DRAINAGE CONDITION DISCHARGE

Document Reference. 1-21554-CCL-DA-001

Planning Application No	136933/FO/2023
Site Location	DIXONS ACADEMY
Description	NEW 2 STOREY CLASSROOM EXTENSION BLOCK AND NEW SPORTS HALL ON EXISTING SCHOOL SITE
Applicant Name	DEPARTMENT FOR EDUCATION

LLFA Drainage comments.

2. Exploratory Hole Location Plan and BRE Testing results.

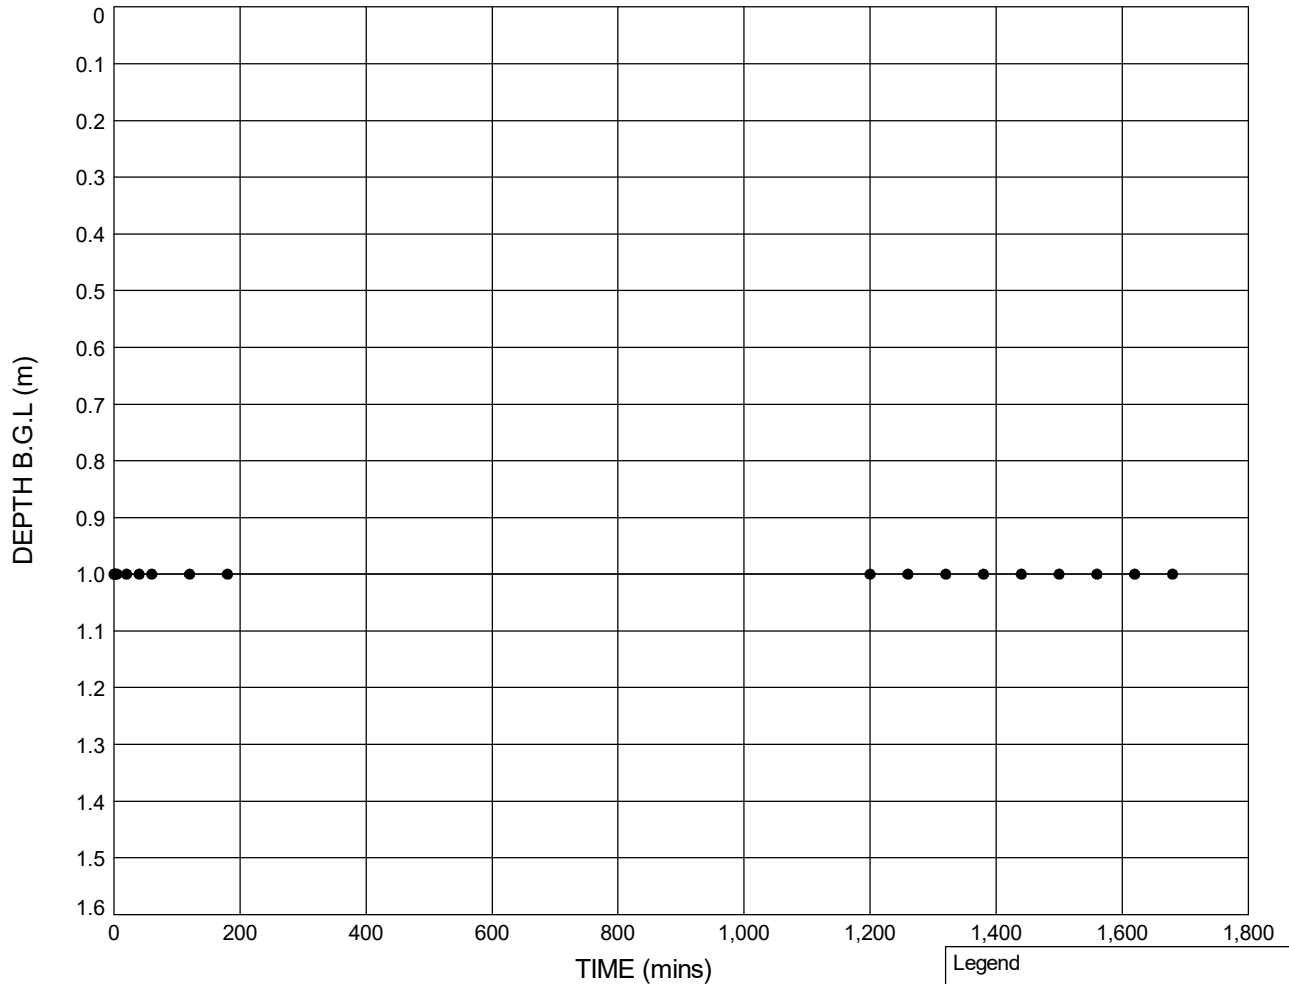
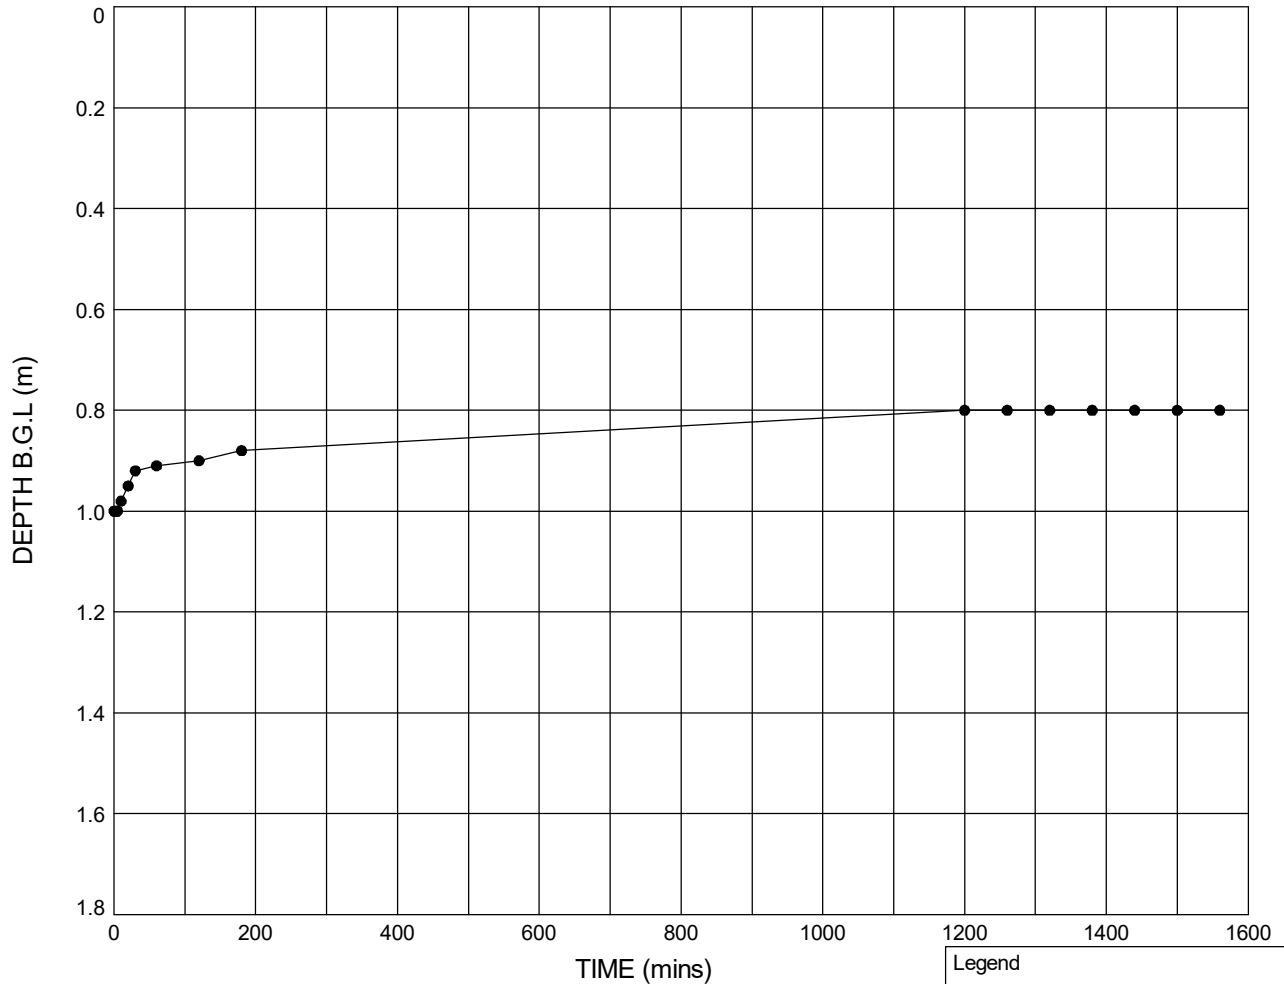
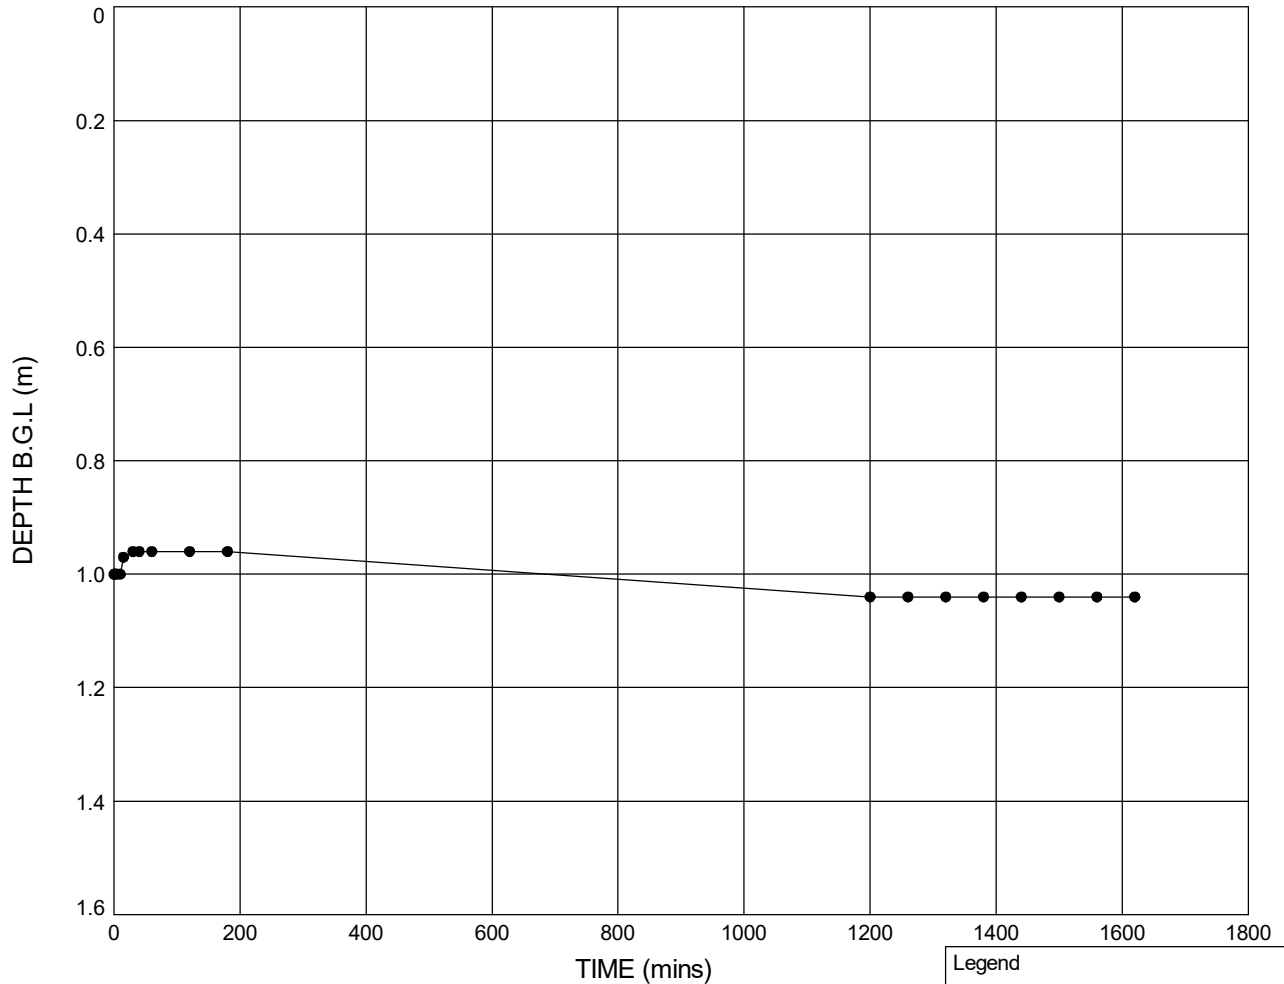
- Maximised integration of green SuDS components (utilising infiltration or attenuation) if practicable.

Refer to Flood Risk and Drainage Strategy document submitted for planning, Ref: FS0998-CCL-SE-8-XX-T-C-0101. Section 6.3.4, 6.3.24 and 6.4. Infiltration testing results appended to the back of this document.

3. Bio-solar Green Roof

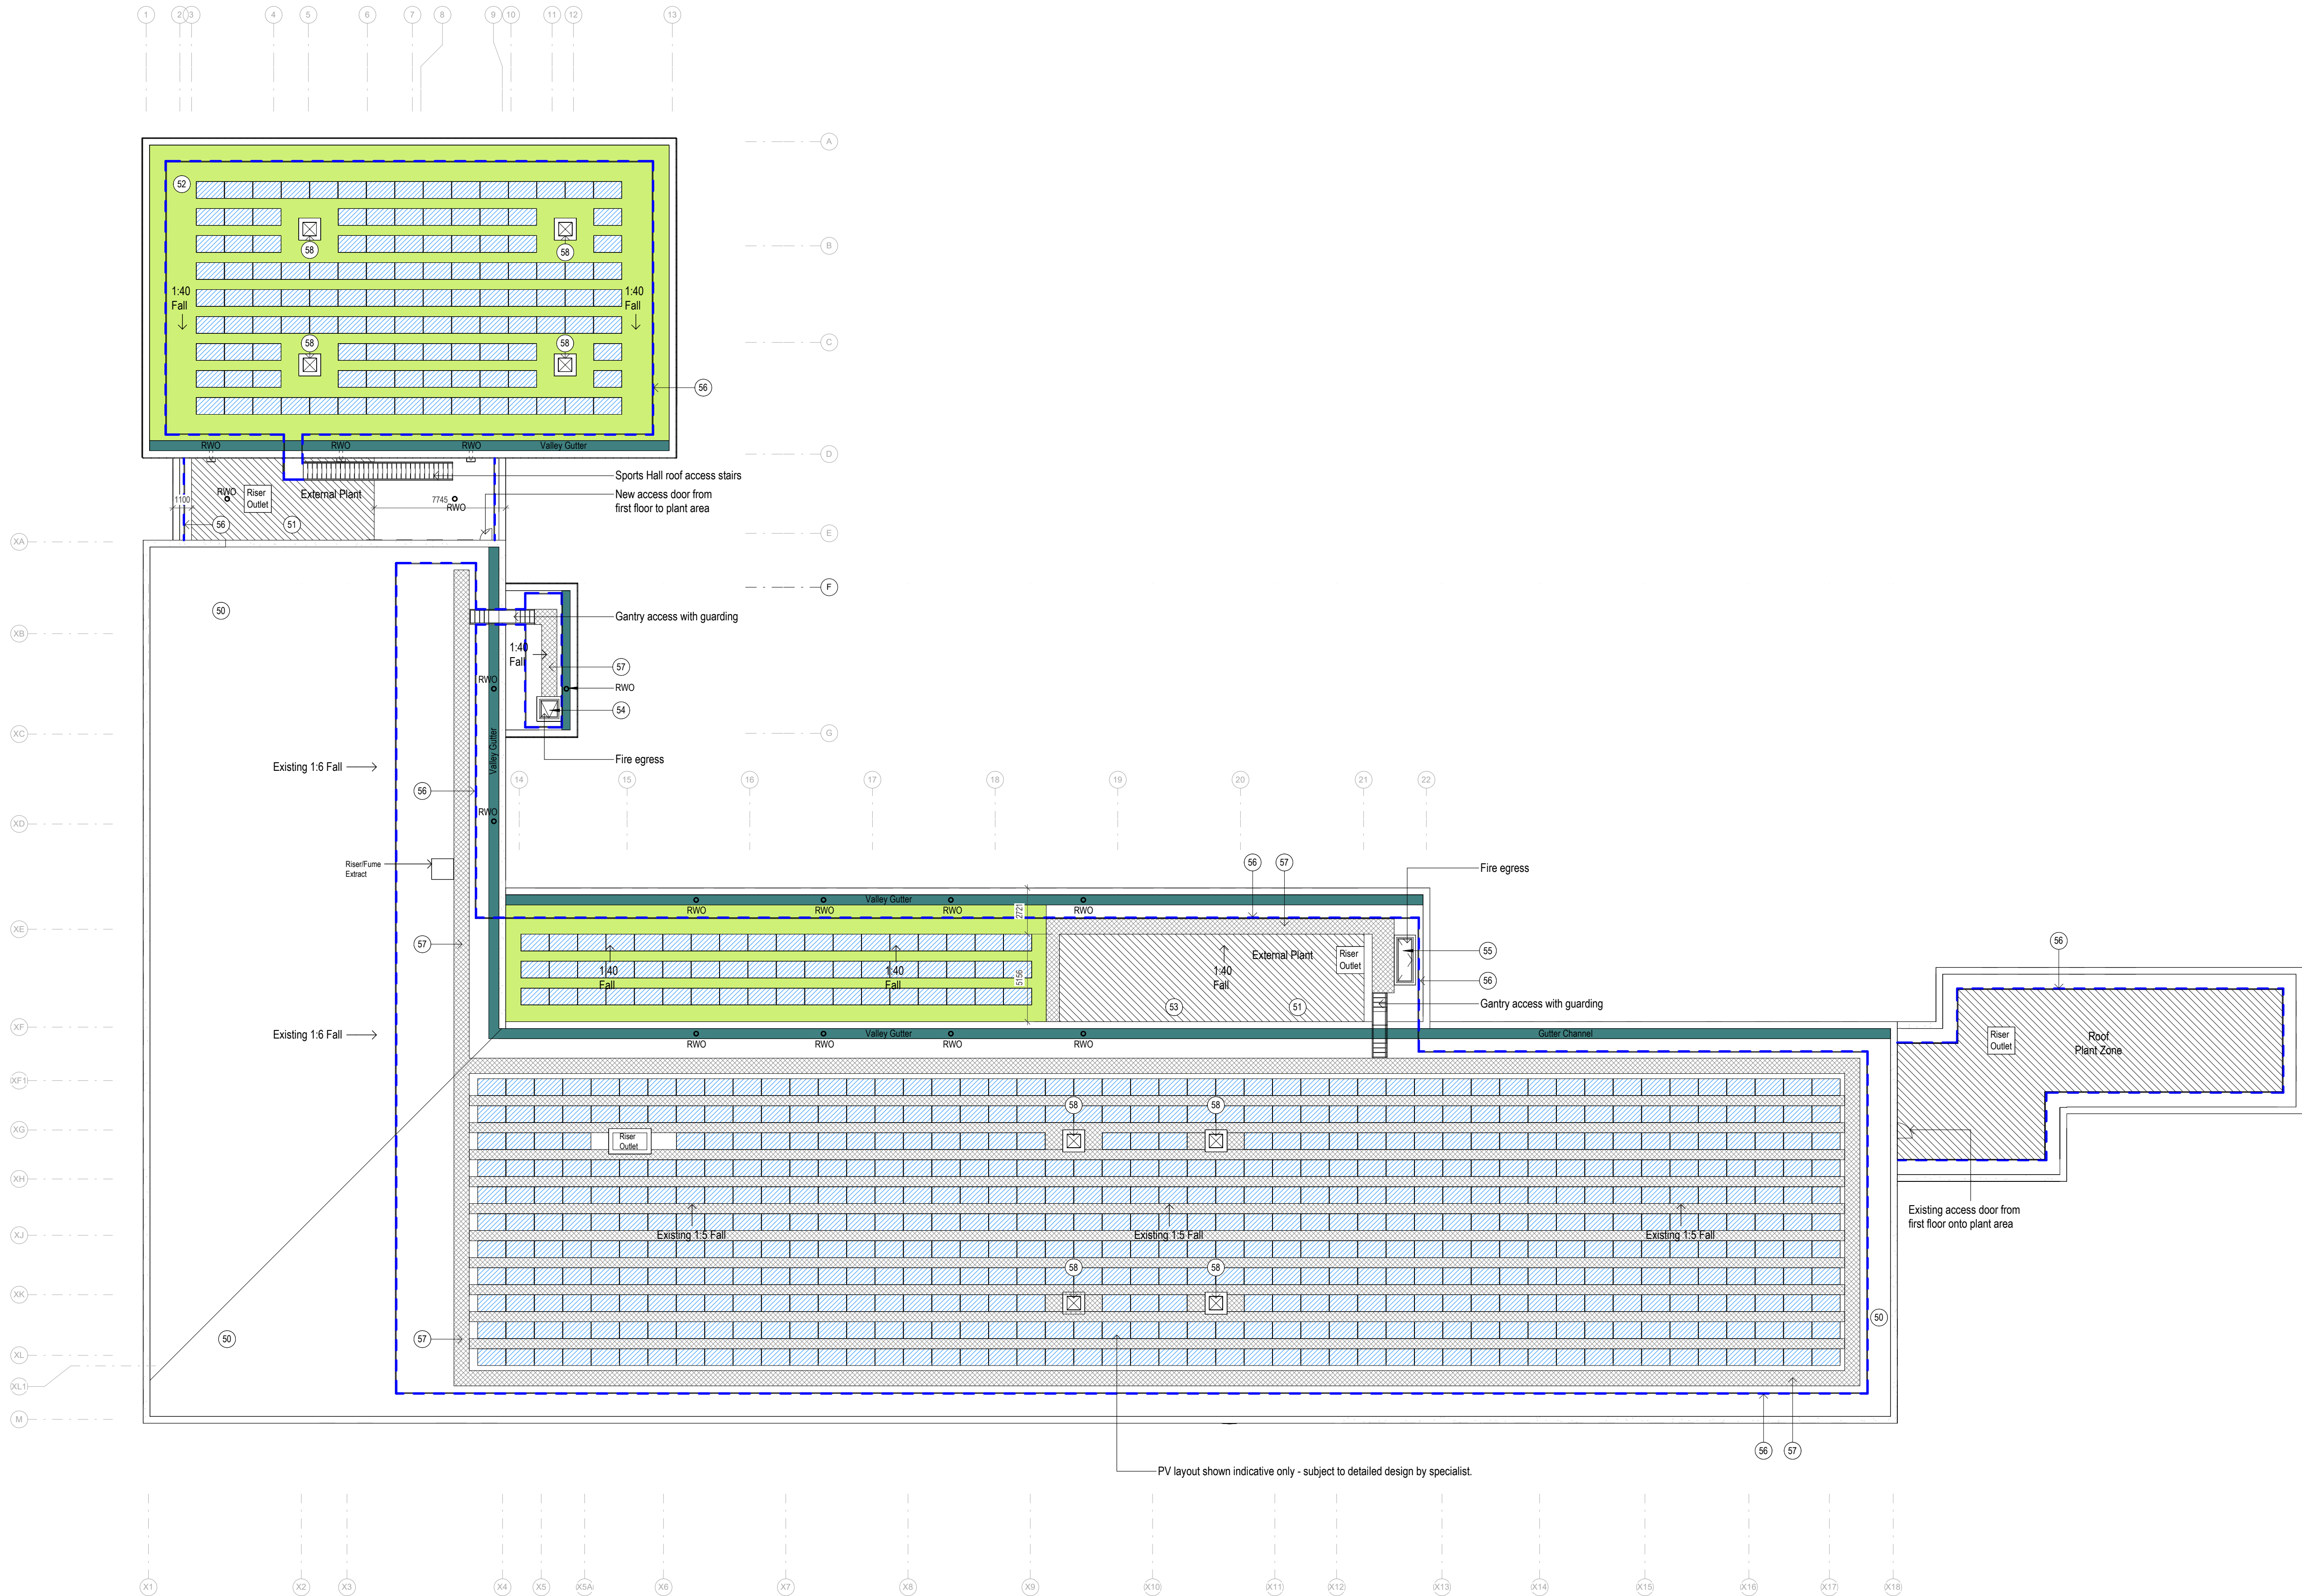
- A feasibility assessment and engineering details of the Green / Blue Roof

A Bio-solar green roof is being proposed and the engineering details can be found appended to this document.
